Access Compliance Report

Public Rights-of-Way

(Curb Ramps)

Intersection ID: 14530	Main Street: E_5TH_ST	Cross Street: N_LAUREL_AV	Location: W
ADA ID: 1D293C9341C4	Ramp Type: Perp	Initial Pass/Fail: Fail	Overall Compliance: No
		Severity Score: 10

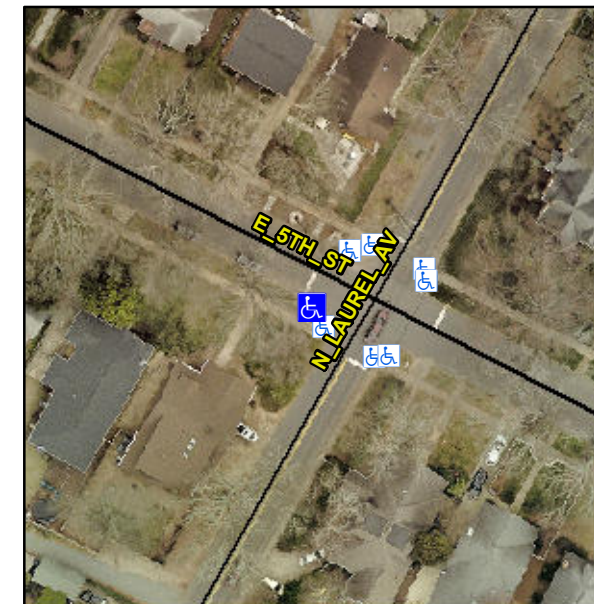
R304.5.1, R304.5.3

Compliance	Description	Data	Compliance	Description	Data
N/A	Ramp Length (in)	58.0	Yes	Ramp Slope (%)	5.1
No	Ramp Width (in)	45.0	No	Ramp XSlope (%)	2.6
N/A	Flare Type LT	N/A	N/A	Flare Type RT	N/A
N/A	Flare Slope LT (%)	N/A	N/A	Flare Slope RT (%)	N/A
N/A	Flare Traversable LT?	N/A	N/A	Flare Traversable RT?	N/A
N/A	Landing Length (in)	N/A	N/A	DWS Provided?	N/A
N/A	Landing Width (in)	N/A	N/A	DWS Contrast?	N/A
N/A	Landing Slope (%)	N/A	N/A	DWS Length (in)	N/A
N/A	Landing X Slope (%)	N/A	N/A	DWS Full Width?	N/A
N/A	Landing Curb? (Y/N)	N/A	N/A	DWS Offset (in)	N/A
N/A	Shared Landing?	N/A			
N/A	Gutter Ponding?	N/A	N/A	Gutter Slope (%)	N/A
N/A	Gutter Lip Ht (in)	N/A	N/A	Gutter X Slope (%)	N/A
N/A	Painted X Walk1?	No	N/A	Painted X Walk2?	N/A
	X Walk 1 Direction	To NE		X Walk 2 Direction	N/A
N/A	X Walk 1 Width (in)	N/A	N/A	X Walk 2 Width (in)	N/A
	X Walk 1 Slope (%)	2.6		X Walk 2 Slope (%)	N/A
	X Walk 1 X Slope (%)	0.4		X Walk 2 X Slope (%)	N/A

Remove & Replace Entire Ramp.
